BCA & DDA Capability Statement

IRT Moruya Seniors Living Development
1 Spencer Street, Moruya NSW 2537

Reference: S250222

+ To	IRT Group c/- APG
+ Attention	Domenic Severino
+ Email	Domenic.severino@apg.com.au
+ From	David Martin
+ Subject	SSDA Stage BCA Capability Report – IRT Moruya – SSDA Review based on stakeholder review and updated design plans
+ Project No.	S250222
+ Revision	3
+ Date	19 March 2026
+ Pages	117

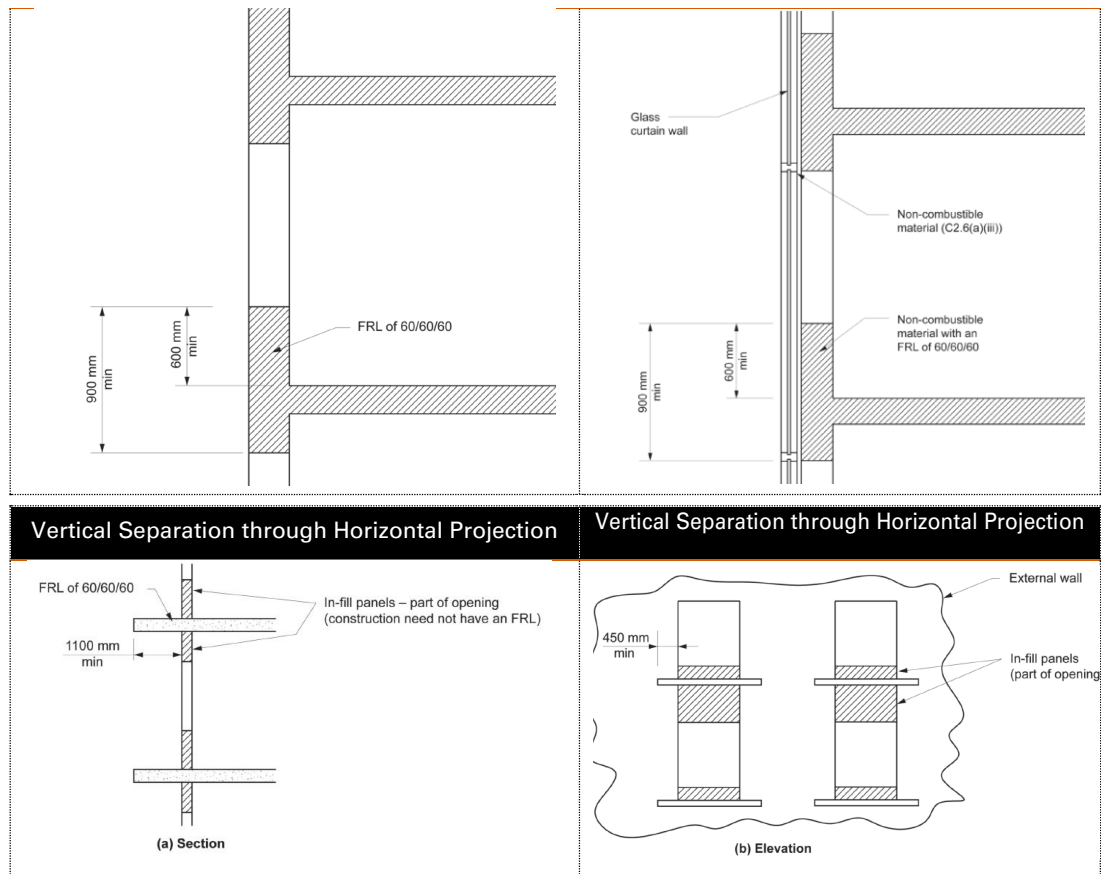
Comment: Documentation is to be provided verifying ancillary use areas, within the meaning of BCA C3D6, are appropriately segregated with smoke-proof construction from resident sleeping areas. All smoke compartments containing resident areas are within 500sqm limitations.

Fire Engineered Solution: The RACF comprises 2 x smoke compartments on ground floor that have a floor area of up to 791sqm and 757sqm respectively, in lieu of not greater than 500sqm within non-resident areas contrary to BCA Clause C3D6(3)(a).

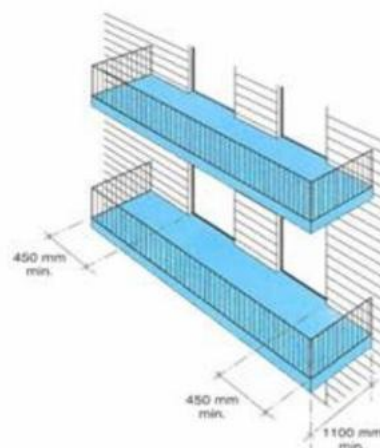
Comment: Where the buildings is to be sprinkler protected in accordance with BCA Spec. 17 and 18 (as per AS2118.1 OR AS2118.4) there is concession such that vertical separation of openings in the external wall is not required. This concession will apply to the Residential Care Facility and ILU Apartments 4 storey 'Spencer Street' Apartments (Building E/F/G/H).

Notwithstanding, the 3-storey 'Valley' apartments (Building A/B/C/D) are Type A Construction and we understand these apartment buildings are not to be sprinkler protected; as such spandrel protection will be required.

Further dimensions will also be required to ensure that vertical spandrels are achieved and 1,100mm and 450mm horizontal projection dimensions are achieved in relation to the balcony lengths and location of windows protected by balconies:
